TECHNICAL MEMORANDUM

Revised Stormwater Infrastructure for Stage 2-5 Flagstone

Meinhardt Urban have been appointed by Peet Flagstone City Pty Ltd to prepare a review of the Stormwater Management Report – Stage 2-5 prepared by Cardno on 14 August 2012. The purpose of the review is to document key changes to the Stormwater Management Report (SMP) to support the Stage 2-5 RFI submission.

Figure 1 – Revised Catchment and Basin Locations

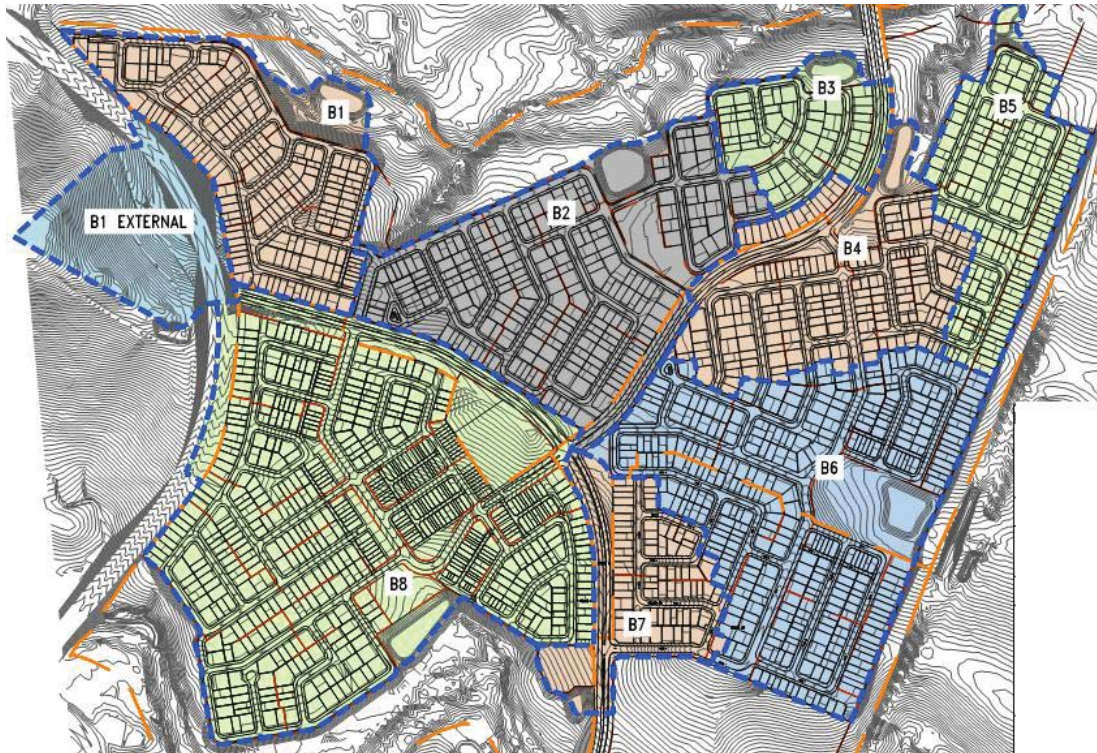
Apart from the above, the key changes to the Stage 2-5 SMP are restricted to changes in catchment boundaries and basin locations.

The key basin locations are located in Figure 1 below:
